**The Corporation of the City of Kawartha Lakes**  
**Committee of Adjustment Report – Inkersell and Battersby**  
Report Number COA2021-033

The variances are requested at 15 Lila Court, geographic Township of Emily (File D20-2021-023).

APPENDIX " C "

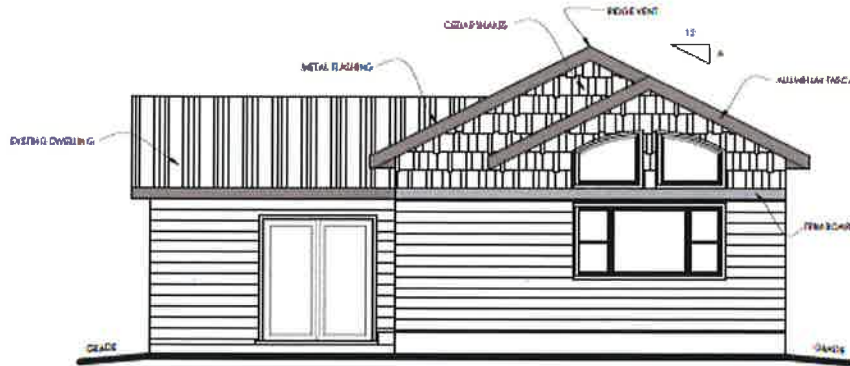
- 2) **That** the owners shall apply for and obtain a building permit from the Building Division for the storage shed and greenhouse-storage shed identified as accessory buildings 1 and 2 on the sketch in Appendix "C" of Report COA2021-033 and submit to the Secretary-Treasurer written confirmation from the Building Division that the permits have been issued and/or are not required,

- 3) **That** within a period of twenty-four (24) months after the date of the Notice of Decision, the owners submit photographic evidence to the satisfaction of the Secretary-Treasurer demonstrating that the greenhouse storage shed has been shifted west to maintain a side yard setback of 1.0 metre in compliance with Section 3.1.2.2 of the Zoning By-law, failing which this application shall be deemed to be refused; and

However, the reduced side lot line setback provides challenges pertaining to providing adequate space for maintenance purposes. As the greenhouse-storage shed has eaves, it is anticipated that these eaves come in very close proximity to and may cross the lot line. Building Division and Development Engineering have also noted concern with the reduced setback. Staff recommend the building be slightly shifted west to comply with the 1 metre side yard setback the zone requires to address all concerns and avoid renovations to the building.

Building Division (May 6, 2021): Concerns with the proposed greenhouse storage shed. A building positioned that close to the lot line will require a 45 minute rating. Moving the building so that it is 0.6 metres from the side lot line will remove this requirement.

Please be advised that the accessory building located at .4m from the property line requires a 45 minute rating. (9.10.14.5 of OBC)

We do note that the greenhouse storage shed has a side lot line setback of 0.45 metres which is not preferred, however we acknowledge it is an existing situation and therefore from an engineering perspective, we have no objection to the proposed Minor Variance.

Staff recommend the building be slightly shifted west to comply with the 1 metre side yard setback the zone requires to address all concerns raised and avoid building alterations that would be required to satisfy Building Division with the proposed reduced proximity.

A setback of .6m would have no implications.

east elevation

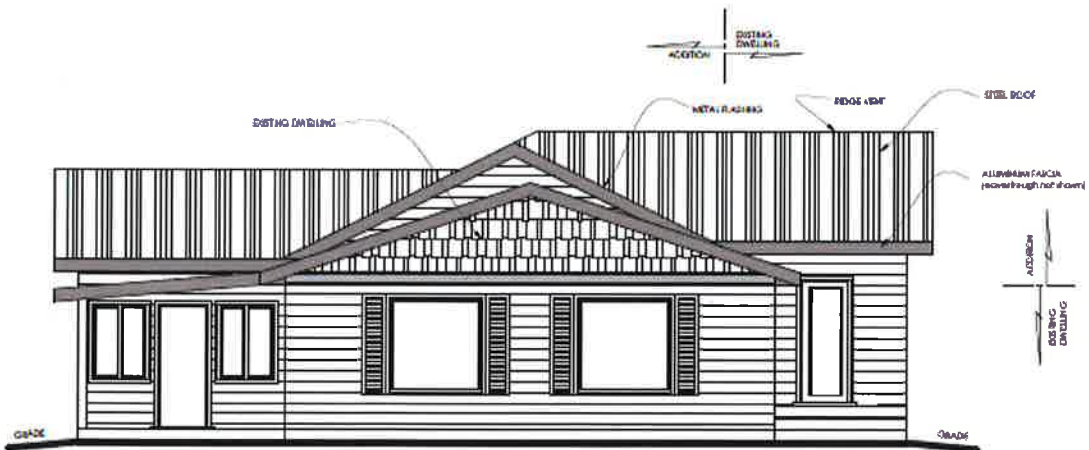
- The structural alterations to the dwelling involve changing the roof above a bedroom from a low sloped roof to a peaked roof, and placing new wall studs to support the roof change.

The water/EP Zone setback reductions will facilitate alterations to the existing single detached dwelling. The alterations will result in an increase in wall height of the north (water facing wall), but will not cause the building to project closer to the water. The building will remain a single storey. The greenhouse-storage shed is in-line with the existing dwelling, is situated within an existing deck area, and provides some storage for recreational water equipment which cannot be accommodated within the smaller and older boathouse to the north. The owners advise that outdoor recreation equipment stored in the boathouse, which was built into the slope and dates to circa 1955, gets mouldy. The greenhouse-storage shed is the only accessory building other than the boathouse within the rear yard. Storing shoreline-related recreational equipment within a building in close proximity to the shoreline also increases the functionality of the shoreline area and provides convenient storage opportunities.
